October 8, 2002
LIC-02-0109

SUBJECT: Fort Calhoun Station Unit No. 1 License Amendment Request, "Reactor Coolant System (RCS) Pressure and Temperature Limits Report (PTLR)"

Pursuant to 10 CFR 50.90, Omaha Public Power District (OPPD) hereby proposes the following amendment to the Technical Specifications (TSs). OPPD proposes to: use a PTLR, change the minimum boltup temperature, modify the TSs to reflect the revised low temperature overpressure protection (LTOP) methodology and analysis that is submitted for review and approval, perform LTOP analyses "in-house", change the LTOP enable temperature, modify TS 2.10.1 to exactly specify the reactor coolant system (RCS) temperature at which the reactor can be made critical, and add a TS for a maximum pressure value for the safety injection tanks (SITs). The use of a PTLR requires the relocation of TS Figure 2-1 (RCS Pressure - Temperature Limits for Heatup, Cooldown, and In-service Test) into Figure 5-1 of the PTLR. As a result of these changes, the

Figure 2-4

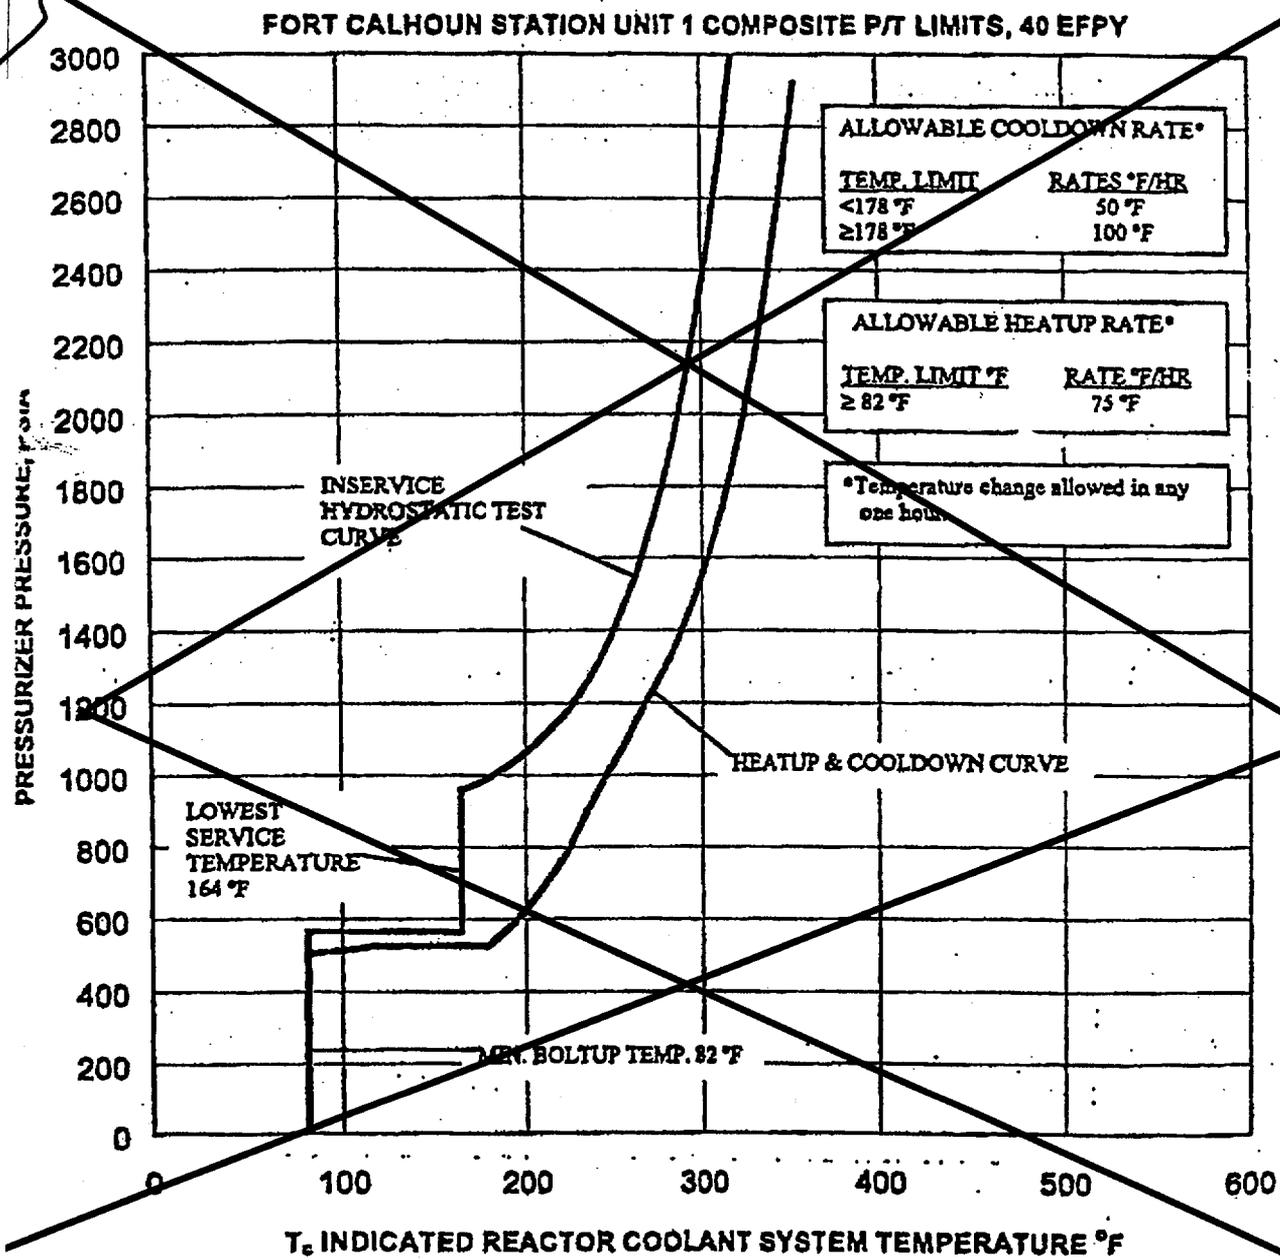
- 1) The proposed changes include relocating TS Figure 2-1 (RCS Pressure - Temperature Limits for Heatup, Cooldown, and Inservice Test) into Figure 5-1 of the PTLR. Figure 5-1 of the PTLR is based on Figure 2-1 of Reference 10.1 and approved by Reference 10.13 with the following modifications:

- a. Allowable combinations of pressure and temperature (T_c) for a specific heatup rate shall be below and to the right of the applicable limit lines as shown on the pressure and temperature (P-T) limit Figure(s) in the PTLR Figure 2-1.
- b. Allowable combinations of pressure and temperature (T_c) for a specific cooldown rate shall be below and to the right of the applicable limit lines as shown on the P-T limit Figure(s) in the PTLR Figures 2-1.
- c. The heatup rate of the pressurizer shall not exceed 100°F in any one hour period.
- d. The cooldown rate of the pressurizer shall not exceed 200°F in any one hour period.

- (a) The P-T limit Figure(s) are Figure 2-4 is valid for a fast neutron ($E \geq 1$ MeV) fluence value and corresponding of 2.15×10^{19} n/cm² which corresponds to 40-EFPY as stated in the PTLR.

- (c) The limit lines in the P-T limit Figure(s) shown in the PTLR Figure 2-4 shall be moved parallel to the temperature axis (horizontal) in the direction of increasing temperature a distance equivalent to the transition temperature shift during the period since the curves were last constructed. The boltup temperature limit line shall remain at 6482°F as it is set by the RT_{NDT} of the reactor vessel flange and is not subjected to a fast neutron flux. The lowest service temperature shall remain at 164°F because components related to this temperature are also not subjected to a fast neutron flux.

- (d) The Technical Specification 2.3(3) shall be reviewed and revised as necessary each time the curves on the P-T limit Figure(s) as shown in the PTLR of Figure 2-4 are revised.

Figure 5-1

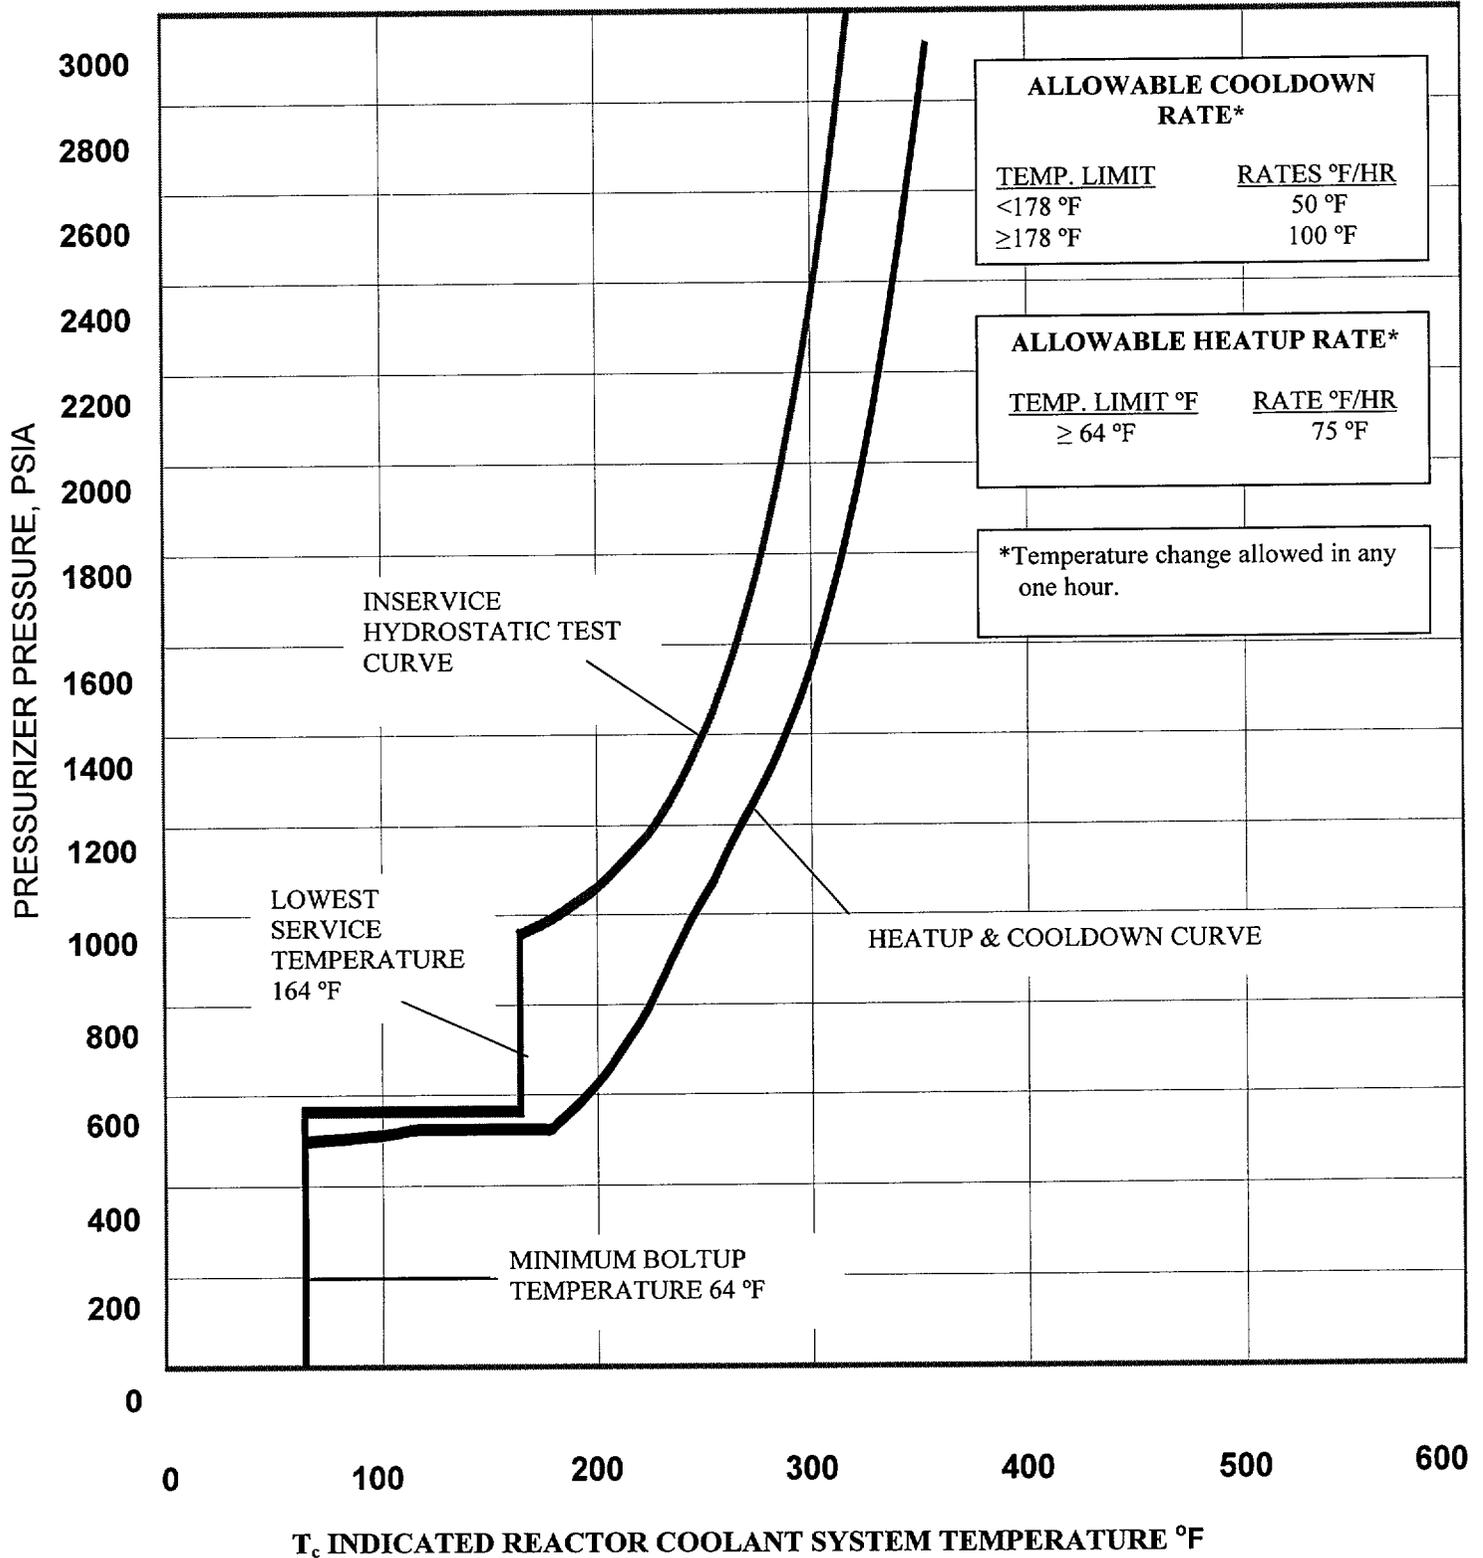
- a) Incorporates a lower minimum boltup temperature from 82°F to 64°F. The P-T limit curve stated in Reference 10.1 was analyzed to an analytical value of 50°F or an indicated temperature of 64°F. Those values below an indicated temperature of 82°F (which corresponded to an approved minimum boltup temperature of 82°F) were not used since the LTOP system at that time was not revised to include this lower temperature. Figure 5-1 of the PTLR uses the same P-T limit values that were used in Figure 2-1 of Reference 10.1 except it incorporates the following additional values from Table 1, Attachment 4a of Reference 10.1 for the heat-up and cooldown curve:

- i) Indicated Temperature of 64°F: 498 psi
 - ii) Indicated Temperature of 74°F: 502 psi
 - b) The LTOP analysis (Reference 10.2) has been revised and uses an analytical value of 50°F or an indicated temperature of 64°F. Figure 2-1 of Reference 10.1 was analyzed to the same temperatures but only incorporated P-T limit values to an indicated temperature of 82°F. The LTOP analysis ensures that the peak pressures during any LTOP event does not exceed any P-T limit from 50°F or greater. Therefore, since Figure 5-1 of the PTLR incorporates the additional P-T limit values from 50°F and greater, the LTOP system is applicable and bounding. OPPD did not invoke the use of American Society for Mechanical Engineer's

- (ASME) Code Case N-514 in its revised LTOP analysis, which allows the P-T limit curve to be exceeded by an additional 10%
- c) The LTOP enable temperature is sensitive to the P-T limit curve only due to where pressure instrument uncertainty is applied. Above the LTOP enable temperature, pressure instrument uncertainty is incorporated into the P-T limit curve and below this temperature it is not. Figure 2-1 of Reference 10.1 incorporated a value of 350°F but maintained an LTOP enable temperature of 385°F due to the previous LTOP analysis, as approved by Reference 10.4, was analyzed to that temperature. The LTOP analysis has been revised to use a value of 350°F (Reference 10.2), hence the excessive conservatism stated in Reference 10.1 is not applicable to Figure 5-1 of the PTLR.

The minimum boltup temperature is 24°F and its basis for the initial RT_{NDT} are stated in Reference 10.1. For any value of minimum boltup temperature from 24°F or greater to be incorporated into the TSs, it must meet two criteria. These criteria are that both the P-T limit curve and the LTOP analysis must be analyzed to that temperature. The P-T limit curve and the revised LTOP system are evaluated to a minimum boltup temperature of 50°F without temperature indication uncertainty or 64°F with temperature indication uncertainty. Even though a lower boltup temperature is justifiable, it is not practicable to OPPD to analyze both the P-T limit curve and the LTOP system to a lower temperature. Therefore a conservative value of 64°F is incorporated into the TSs and Figure 5-1 of the PTLR which includes instrument uncertainty.

The LTOP enable temperature is sensitive to the P-T limit curve only due to where pressure instrument uncertainty is applied. Above the LTOP enable temperature, pressure instrument uncertainty is incorporated into the P-T limit curve and below this temperature it is not. The P-T limit curve submitted in Reference 10.1 incorporated a value of 350°F but maintained an LTOP enable temperature of 385°F due to the previous LTOP analysis was analyzed to that temperature. The LTOP analysis has been revised to use a value of 350°F (Reference 10.2), hence the excessive conservatism stated in Reference 10.1 is not applicable to Figure 5-1 of the PTLR.

- a. Minimum Boltup Temperature: 64°F.
- b. Minimum Hydrostatic Temperature test limits: See Figure 5-1. (Note: The in-service hydrostatic test curve is developed in the same manner as the heatup and cooldown curves with the exception that a safety factor of 1.5 is used in lieu of 2.)
- c. Lowest Service Temperature: 164°F.
- d. Flange Limit:
 - 1) Normal Operation: 144°F.
 - 2) Hydrostatic and Leak Testing: 114°F.
- e. Core Critical Temperature Limit: 300°F. (Note: This minimum temperature value that must be attained prior to reactor criticality is based on fracture mechanics
